July 24, 2024
Project #010014-01-217

RE: PR-2020-004218 CHICK-FIL-A 5009 MONTGOMERY BLVD NE – RESPONSE TO CYCLE 1 REVIEW

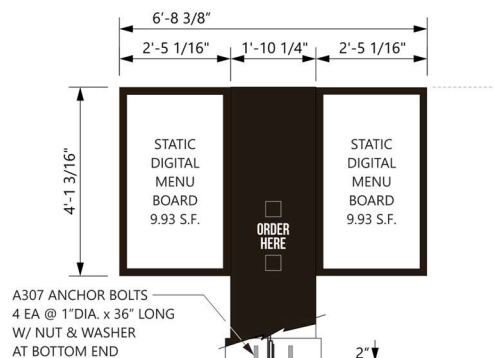
17. 4-3(F)(5)(a) Each stacking lane is limited to a maximum order board area of 50 square feet. The face of the order boards shall be oriented away from public streets to the maximum extent practicable. If not practicable, at least 2 evergreen trees shall be planted in the landscape buffer area required by Subsection 14-16-5-5(l)(2)(a) in locations that would best screen the order board from the public right-of-way. Confirmation must be provided on the Site Plan and in a comment response letter how this Standard is being met for the new drive-through lane vis-à-vis Montgomery Boulevard.

Response: Menu boards are less than 20 square feet each. See detail below. Menu boards screened from public right of way with existing brick screening wall.

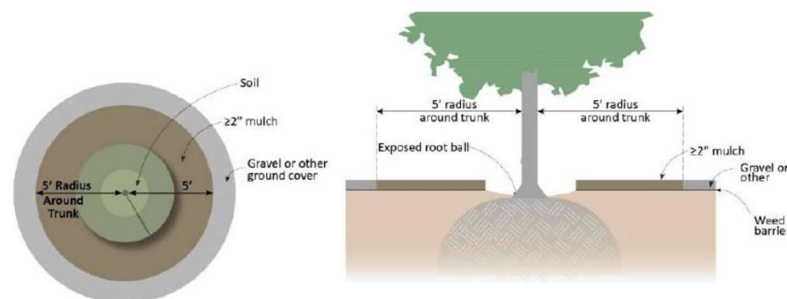
20. Per City Forester's comment, replace the plum tree with a different tree species such as Pink Pom Poms Redbud, Russian hawthorn, Paul's Scarlet Hawthorn, and Golden rain tree.

Response: Species has been replaced as requested. Please see revised Landscape Plan.
